**CENTER AISLE HANDRAILS IN SECTIONS 1-9
WILLIAMS BRICE STADIUM
UNIVERSITY OF SOUTH CAROLINA
CP00349450**

**Addendum One
June 4, 2012**

CENTER AISLE HANDRAIL ADDITIONS SECTIONS 1-9
WILLIAMS-BRICE STADIUM
UNIVERSITY OF SOUTH CAROLINA

RAIL SECTION
3" = 1'-0"

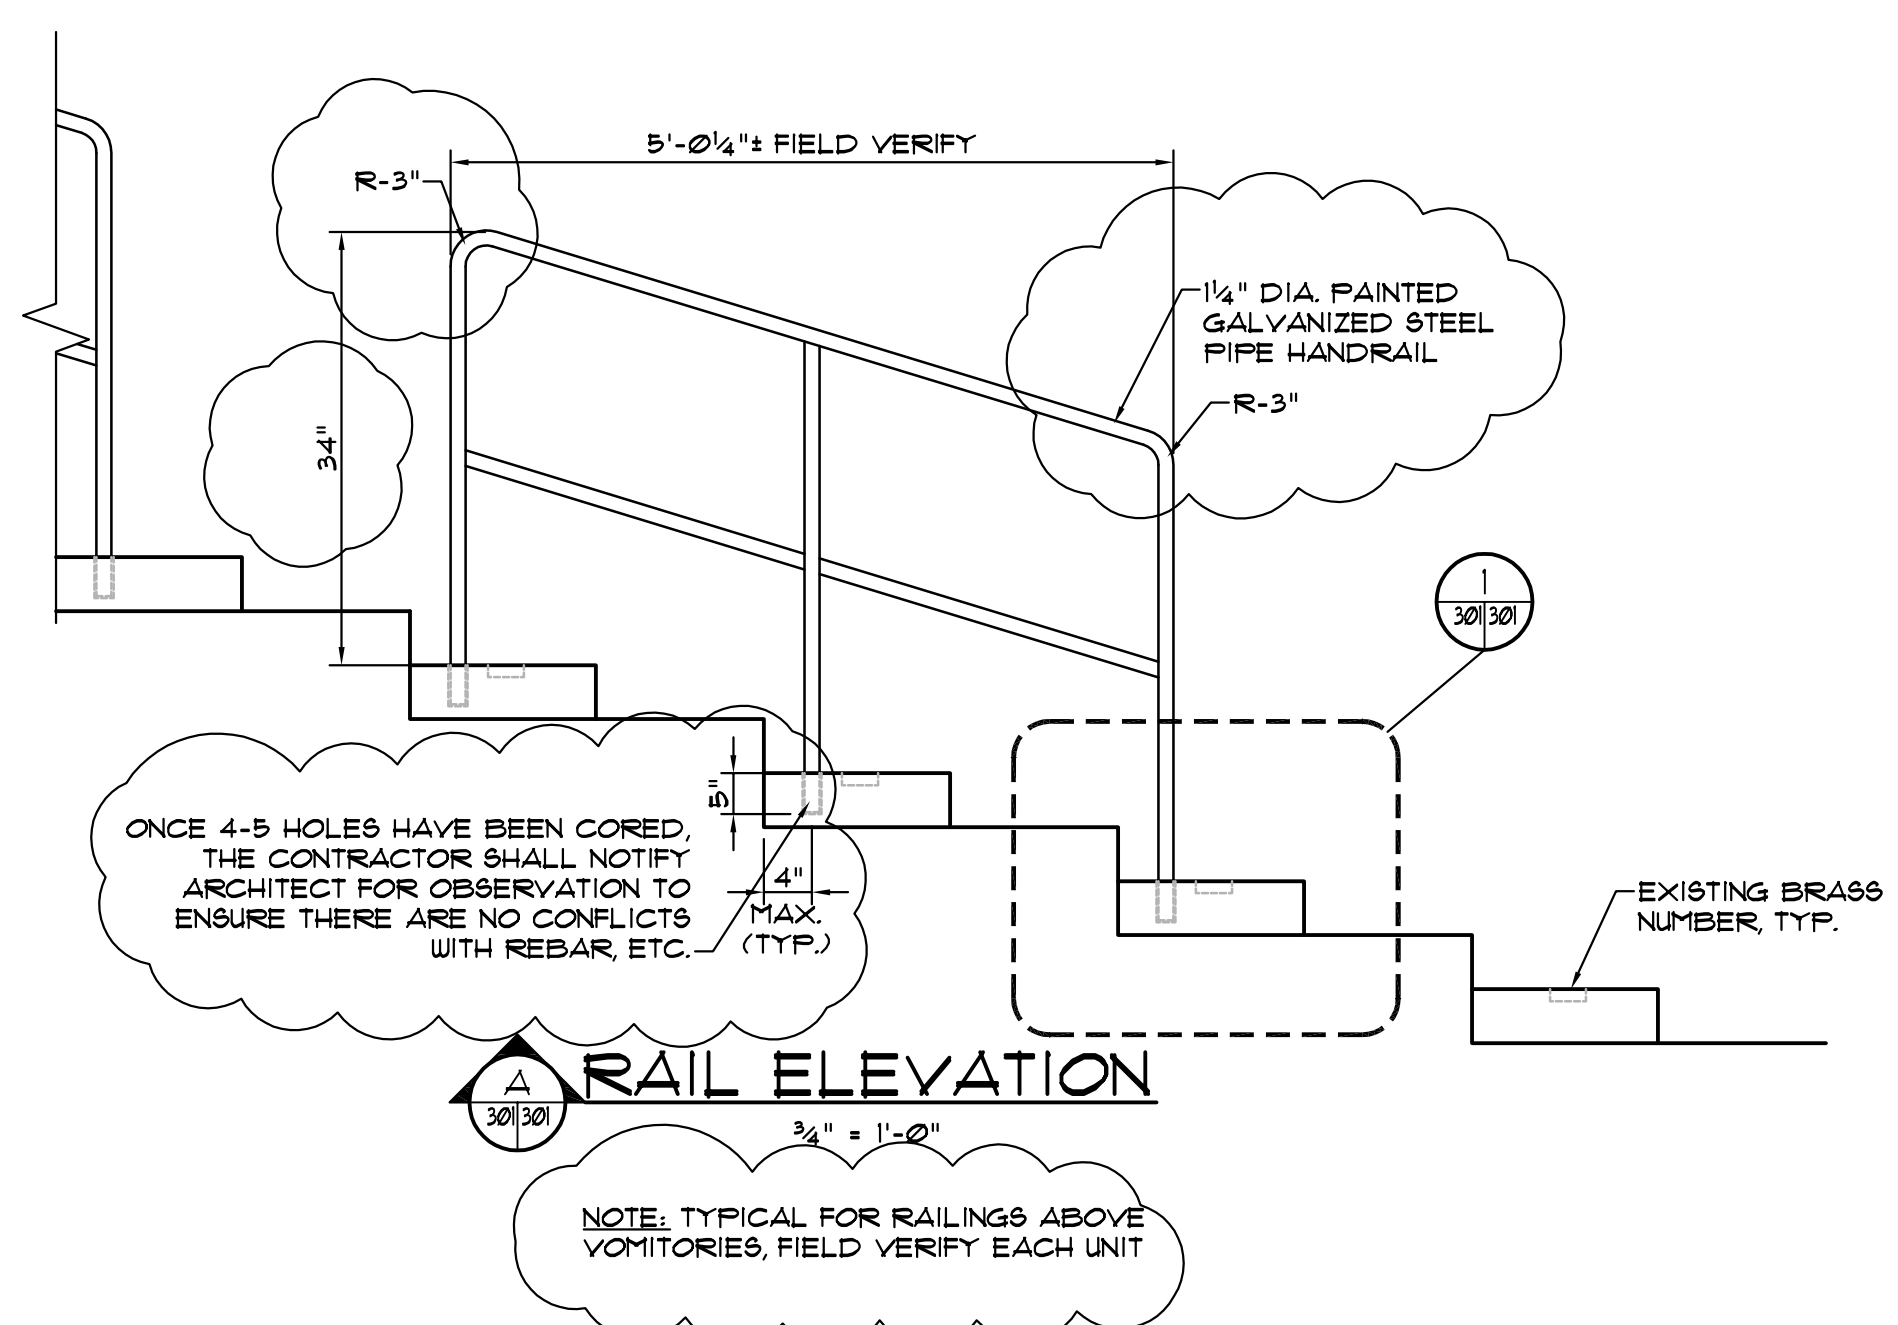
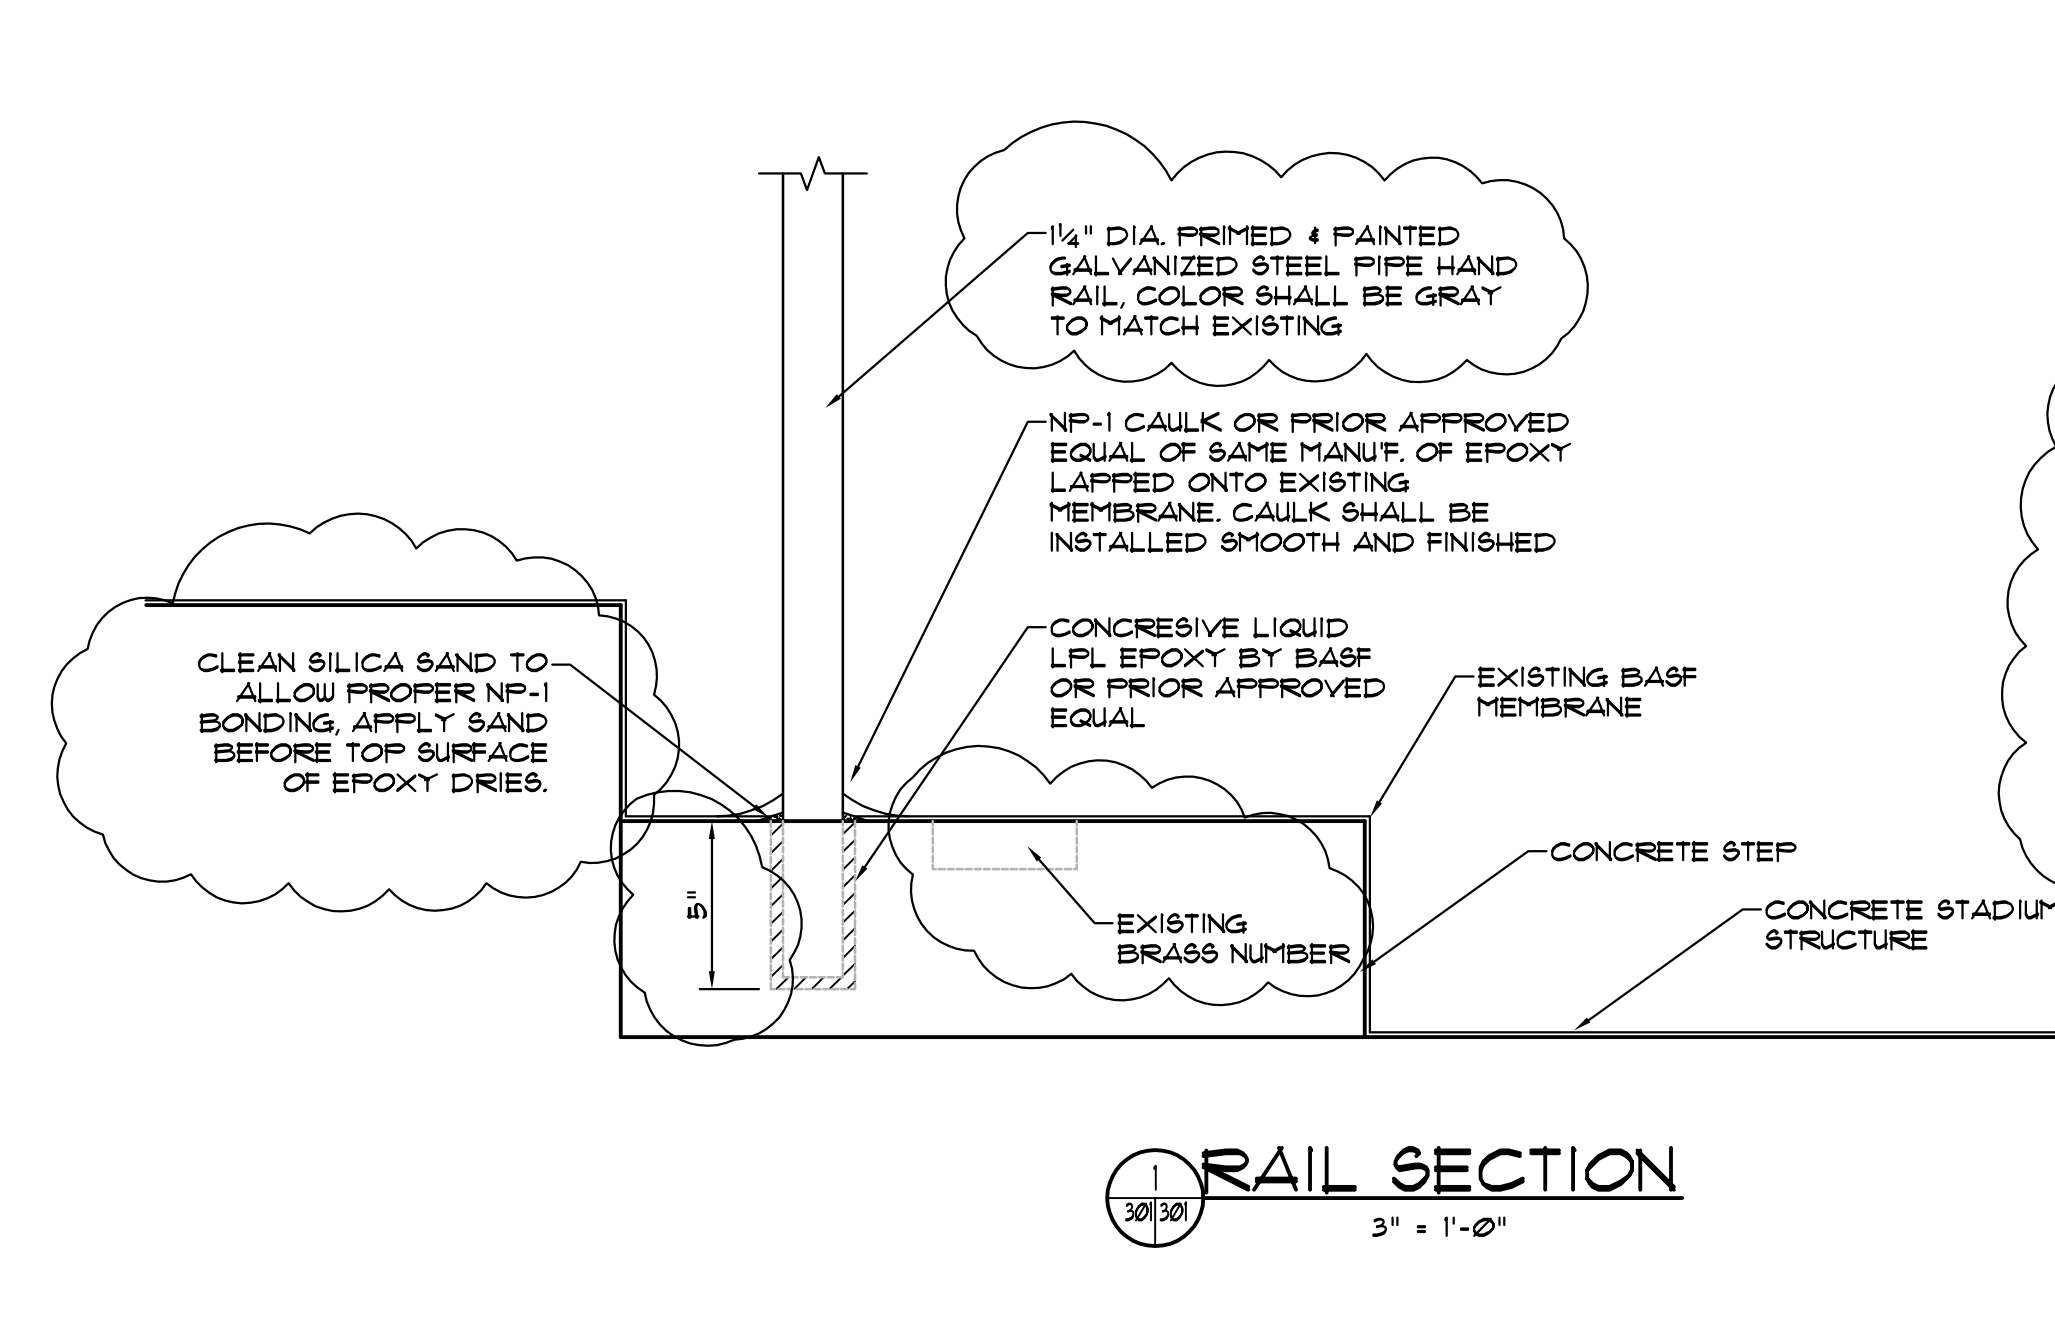
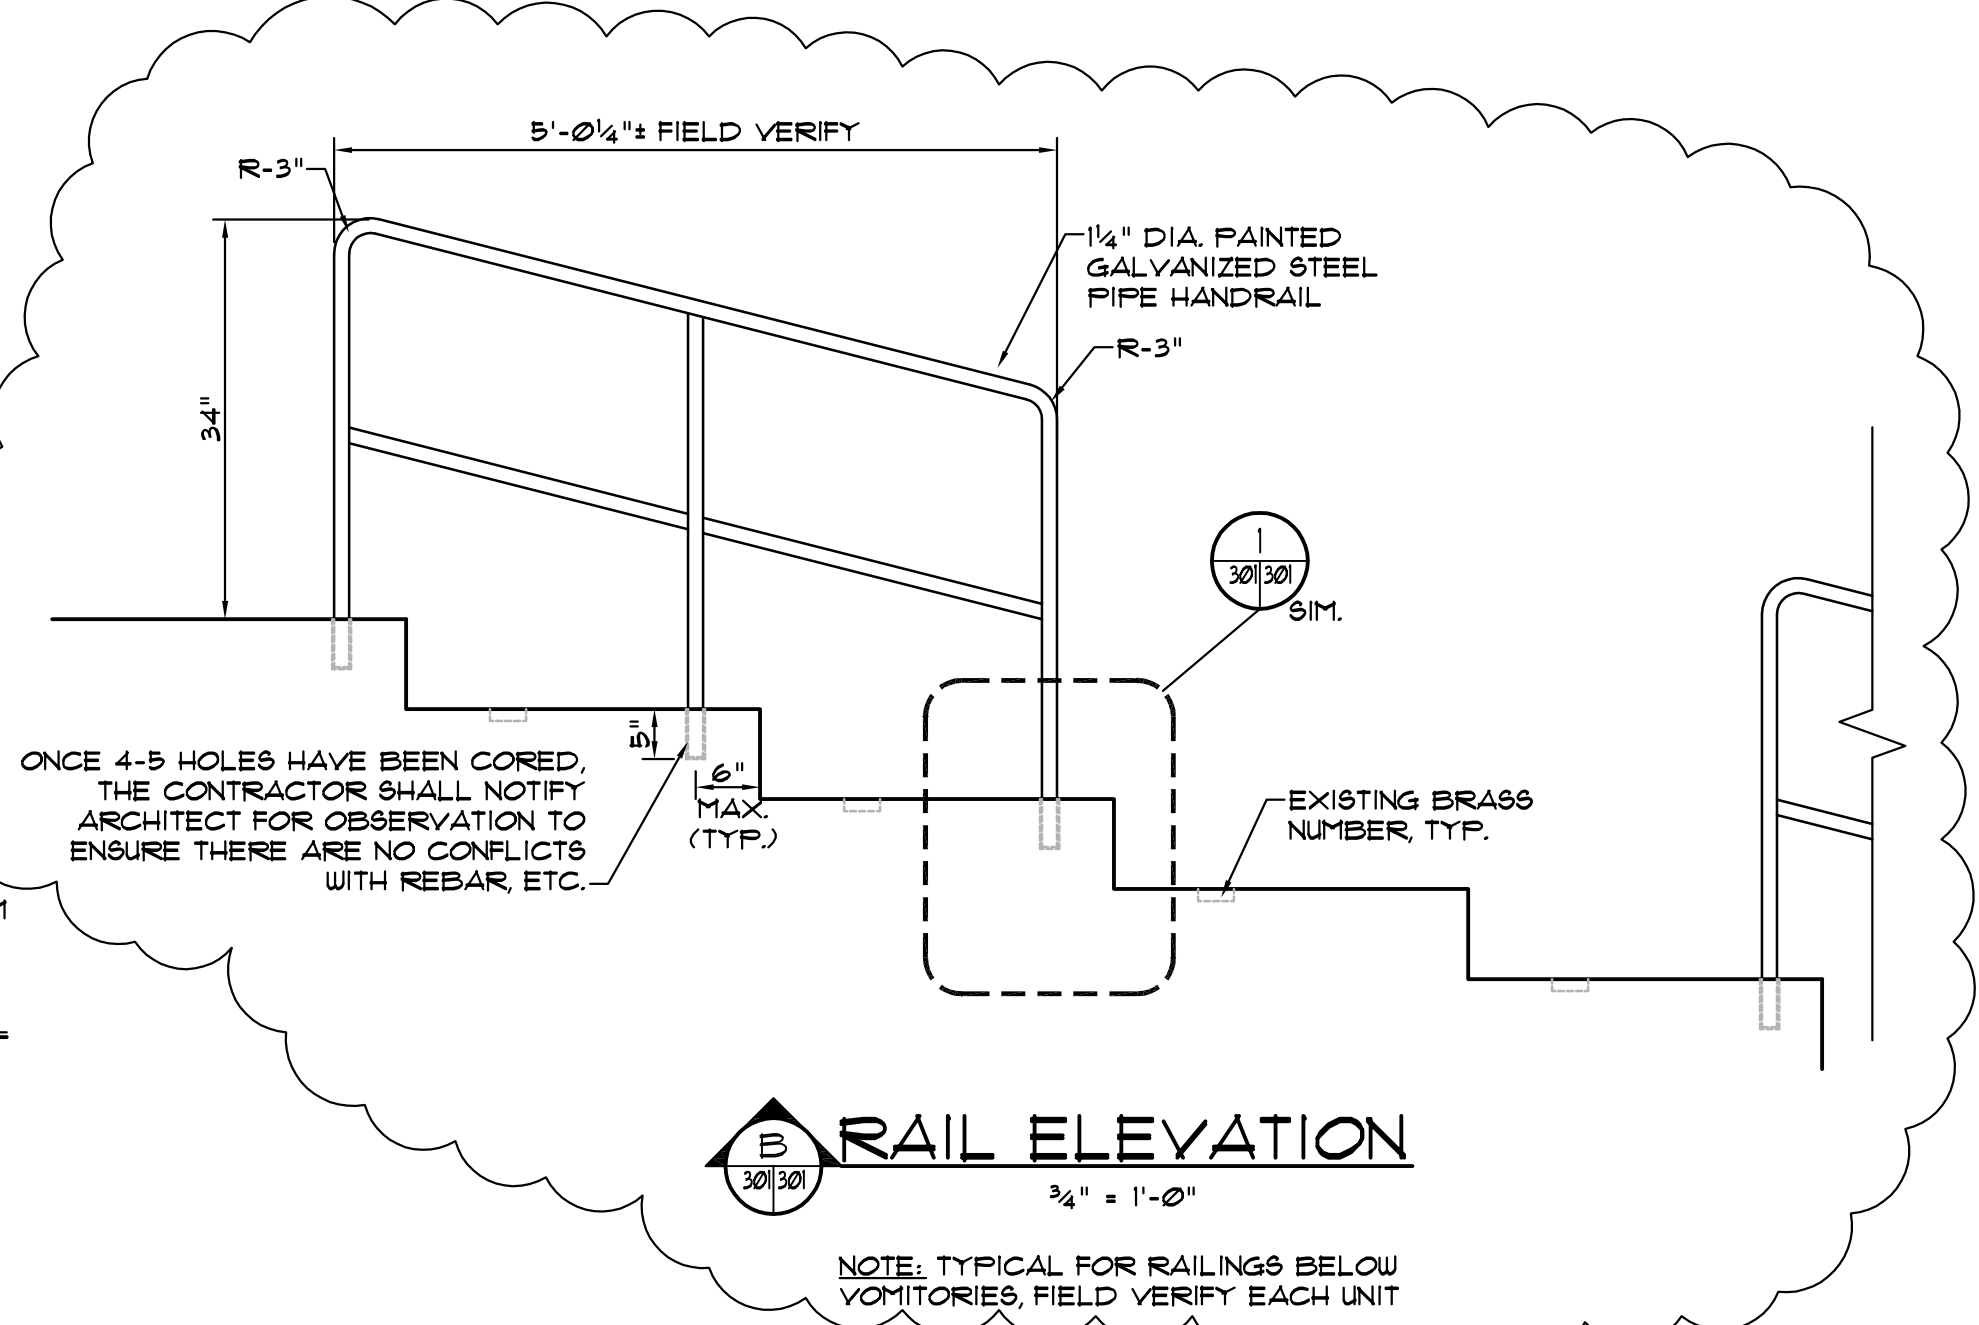
It is important to note as indicated on the revised details that the core depth for the rails shall be 5” deep. Once 4-5 holes have been cored above and below vomitory, the contractor shall notify the architect for observation to ensure there is no conflicts with rebar, etc.
